GIVEN THE TIME THAT HAS PASSED SINCE TSM 462 WAS APPROVED, IT IS ASSUMED NEW ENTITLEMENTS WILL NEED TO BE PROCESSED

**TSM 462 (08TE)**
CALWEST DEVELOPMENT
1320 RICHLAND ROAD

# TENTATIVE MAP NO. T.S.M. 462
# CITY OF SAN MARCOS

# HERITAGE RANCH

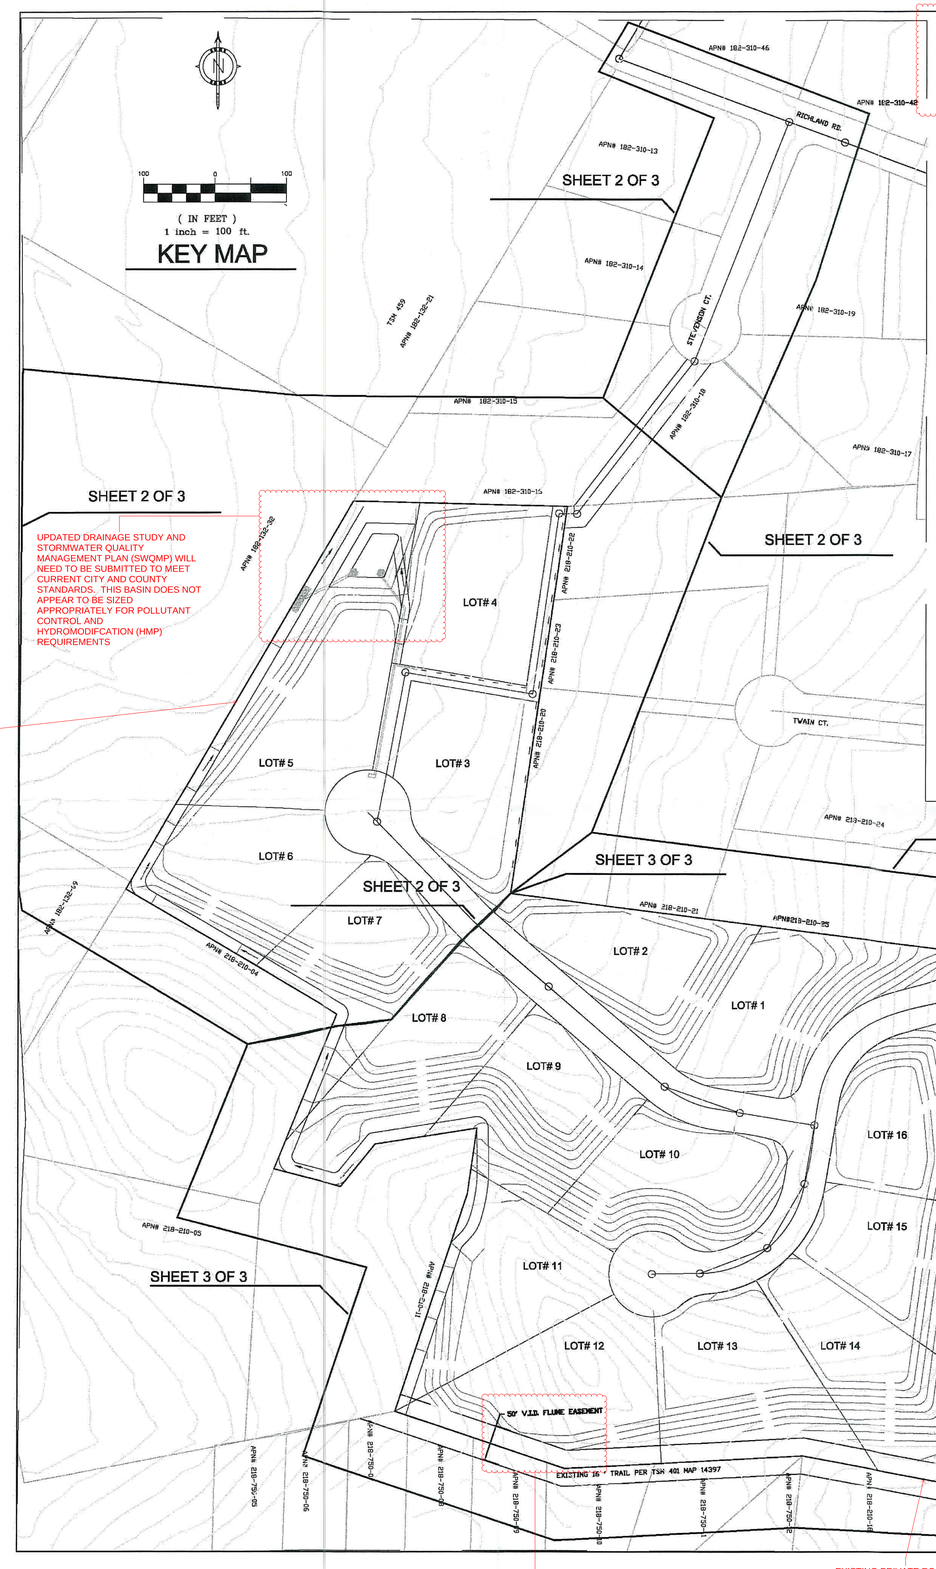
UPDATED DRAINAGE STUDY AND STORMWATER QUALITY MANAGEMENT PLAN (SWQMP) WILL NEED TO BE SUBMITTED TO MEET CURRENT CITY AND COUNTY STANDARDS. THIS BASIN DOES NOT APPEAR TO BE SIZED APPROPRIATELY FOR POLLUTANT CONTROL AND HYDROMODIFCATION (HMP) REQUIREMENTS

PLEASE DEPICT STORM DRAIN CONNECTIONS TO EXISTING SD INFRASTRUCTURE. POST-DEVELOPMENT FLOWS MUST BE EQUAL TO OR LESS THAN PRE-DEVELOPMENT

STREET A – STA. 10+00 TO 17+86±
STREET B – STA.10+00 TO 16+83±
NOT TO SCALE

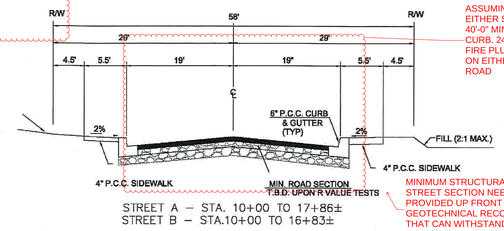
ASSUMING PARKING ON EITHER SIDE, IF SO, 40'-0" MINIMUM CURB TO CURB. 24'-0" CLEAR FOR FIRE PLUS 8'-0" PARKING ON EITHER SIDE OF ROAD

MINIMUM STRUCTURAL THICKNESS OF STREET SECTION NEEDS TO BE PROVIDED UP FRONT BASED ON GEOTECHNICAL RECOMMENDATIONS THAT CAN WITHSTAND 75,000 LB FIRE TILLER LOADING

RICHLAND ROAD – STA. 10+00 TO 18+03±
NOT TO SCALE

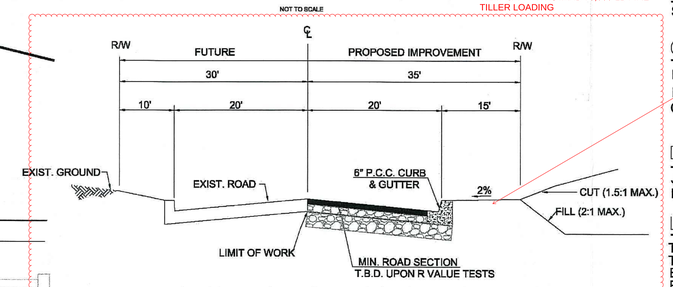
PLEASE NOTE THAT THE ENTIRETY OF RICHLAND ROAD ALONG THE PROERTY FRONTAGE APPEARST TO BE OUTSIDE THE JURISDICTION OF THE CITY OF SAN MARCOS

UPDATE CROSS SECTION TO REFLECT EXISTING RICHLAND

PLEASE PROVIDE PROPOSED FRONTAGE IMPROVEEMNTS AS PART OF CROSS SECTION

TRAIL DITCH SECTION
NOT TO SCALE:

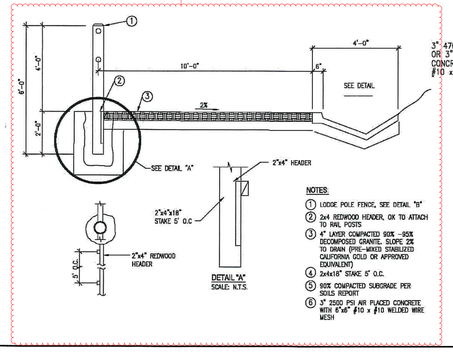
TRAIL CROSS SECTION AND AMENITIES ALONG THE LENGTH OF THE PROPOSED TRAIL TO BE VETTED DURING ENTITLEMENT REVIEW FOR COMPLIANCE WITH CITY TRAIL MASTER PLAN
